HISTORIC AND DESIGN REVIEW COMMISSION

HDRC CASE NO: 2016-421
ADDRESS: 327 RIVERSIDE DR
331 RIVERSIDE DR
LEGAL DESCRIPTION: NCB 7456 LOT 1 (1.564 AC), A3 (2.368 AC), A4 (4.116 AC), A7(.678 AC), & A8 (1.583 AC)
ZONING: I-1 RIO-5
CITY COUNCIL DIST.: 3
APPLICANT: Michael Frere
OWNER: Stampede Industries, LLC
TYPE OF WORK: Signage
REQUEST:

The applicant is requesting conceptual approval to install signage at 327 and 332 Riverside for 84 Lumber. The proposed signage includes:

Re: 84 Lumber Company – 327 & 331 Riverside Drive, Signage Narrative

01 NORTH ELEVATION
SCALE: 1/8"=1'-0"

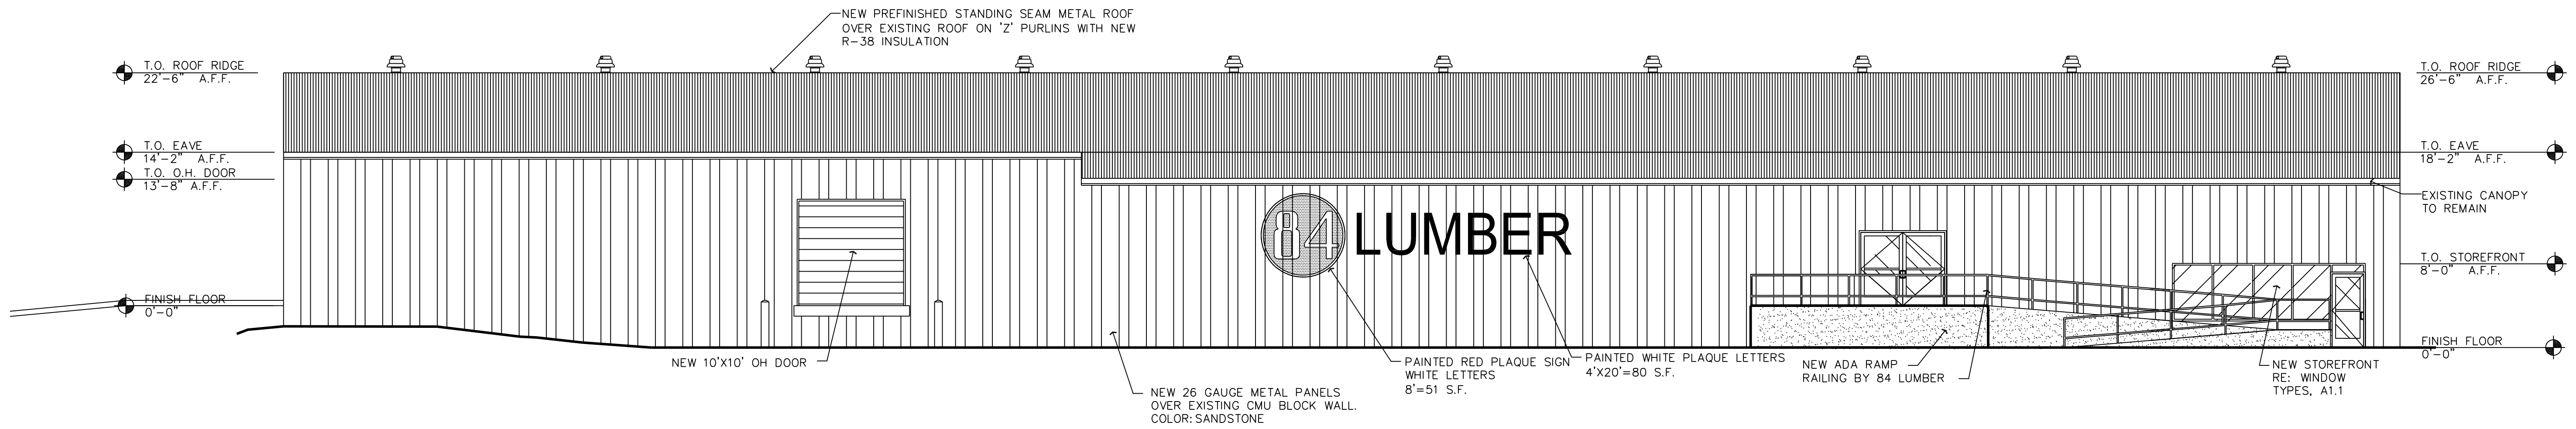
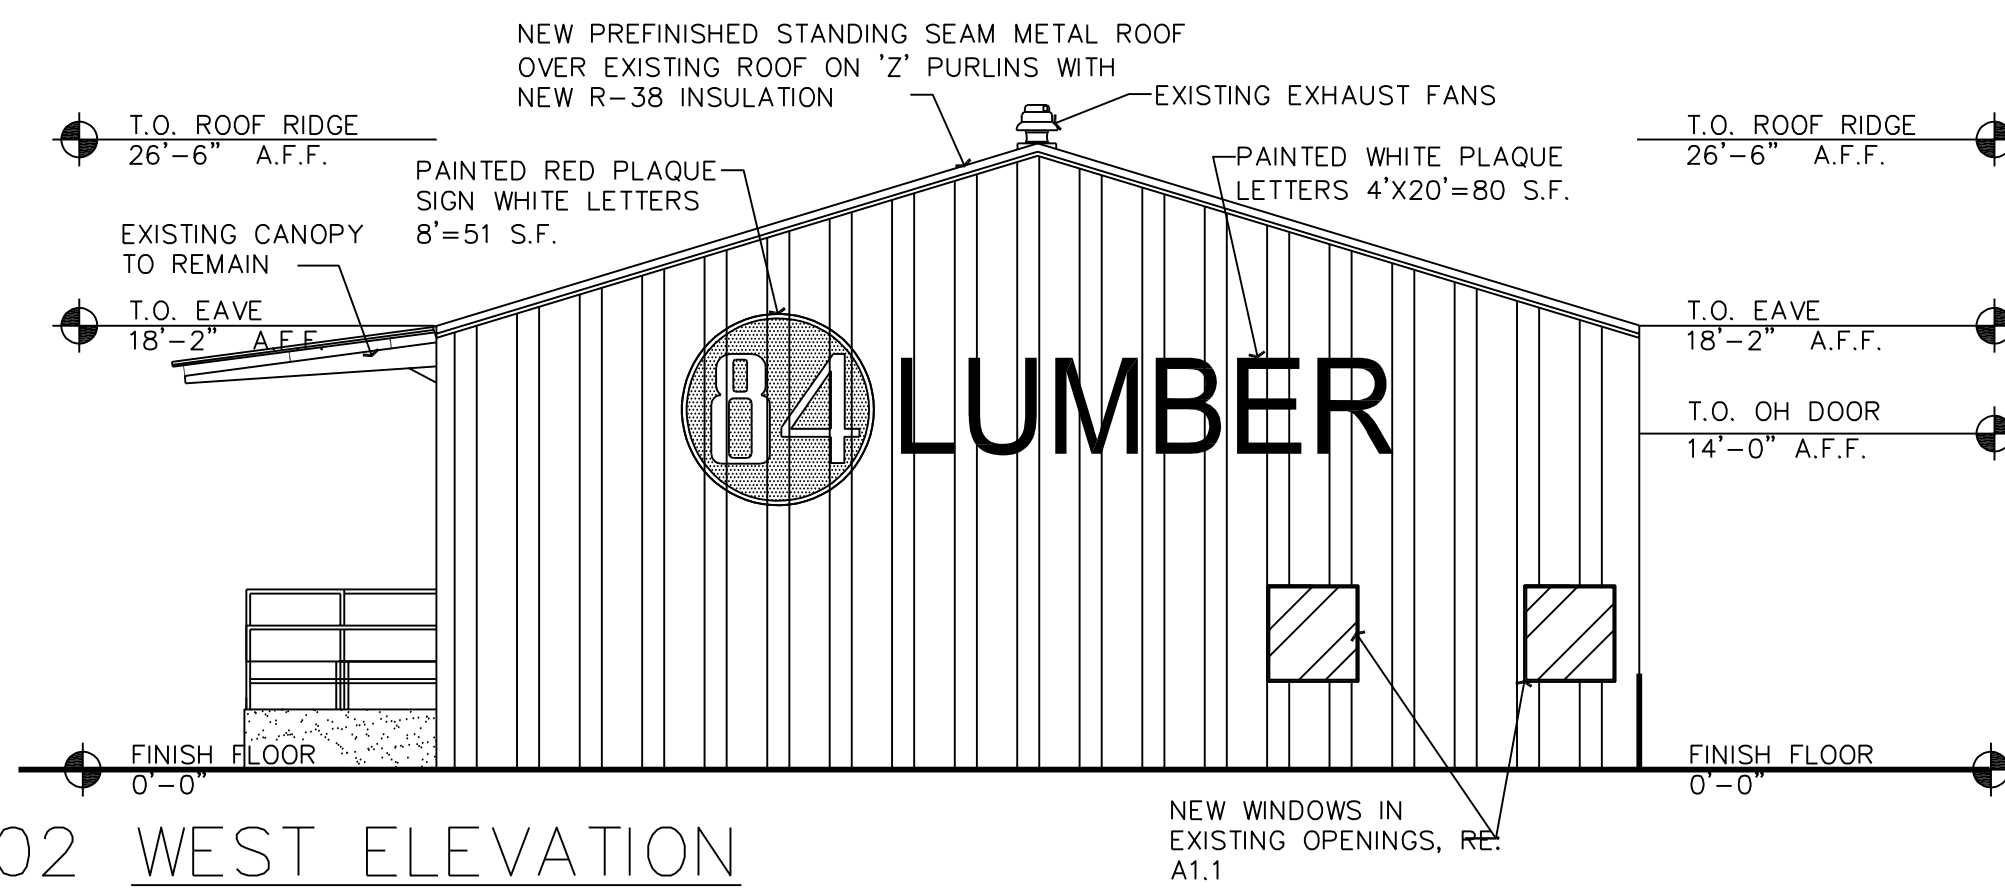
- c. On both the north and west elevations the applicant has proposed to paint an 84 Lumber sign. Both signs are to be non-illuminated and will feature approximately 130 square feet each. Given the industrial nature of this property and those immediately adjacent as well as the non-illuminated state of these signs, staff finds their proposed square footage appropriate.

Staff recommends approval as submitted based on findings a through c.

STORE #:
SCALE: 3/4" = 1'-0"
DRAWING #: 84 LUMBER-SAN ANTONIO TX-MON

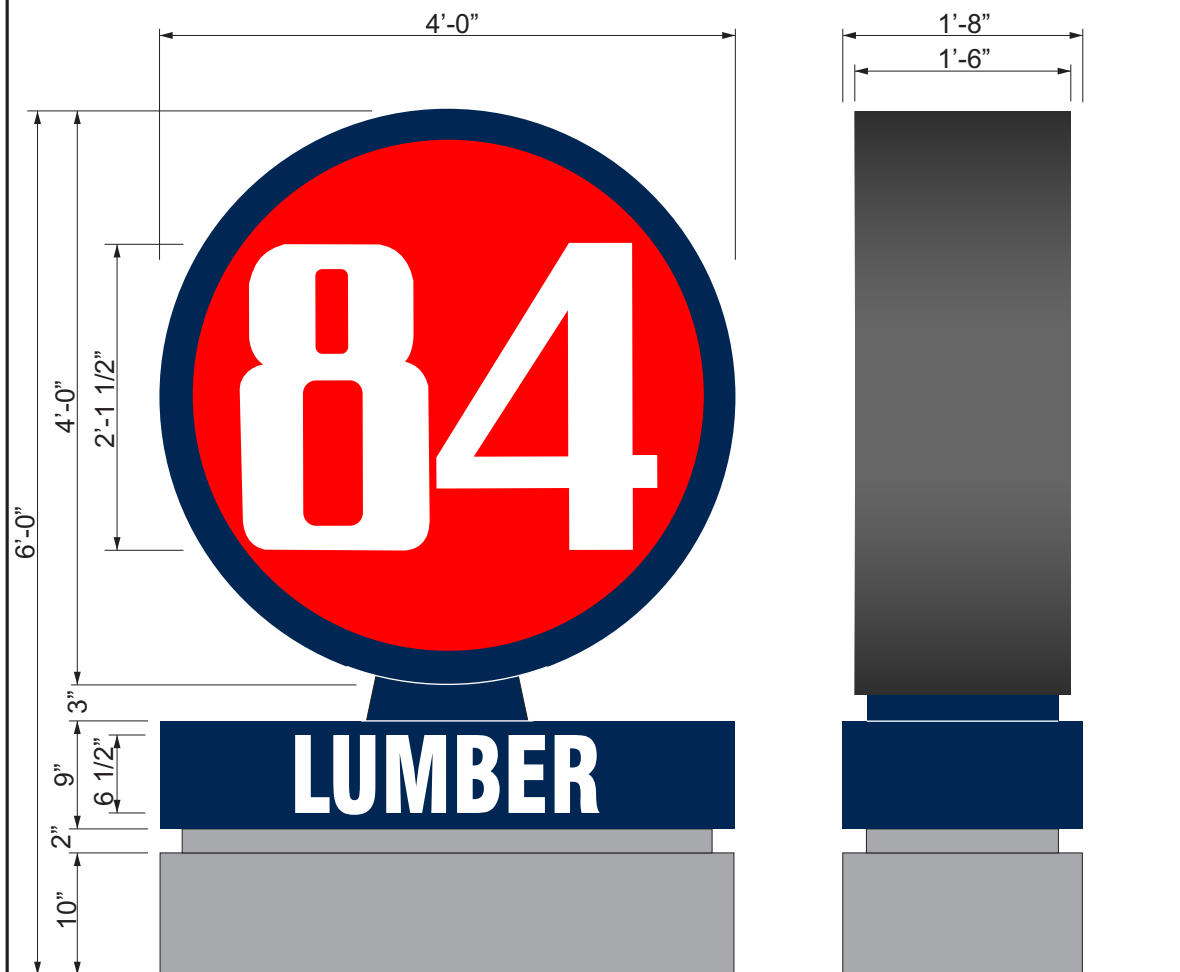
- a. The structure at 327/331 Riverside Drive is an industrial warehouse constructed circa 1955. The property is zoned industrial and is in the River Improvement Overlay – 5.
- b. The applicant has proposed to install one monument sign to feature an aluminum cabinet with routed aluminum faces. The sign is to be internally illuminated featuring red, white and blue cabinet colors. The total square footage proposed is 38 square feet. The applicant's colors, material, lighting scheme and overall square footage are consistent with the UDC Section 35-678.
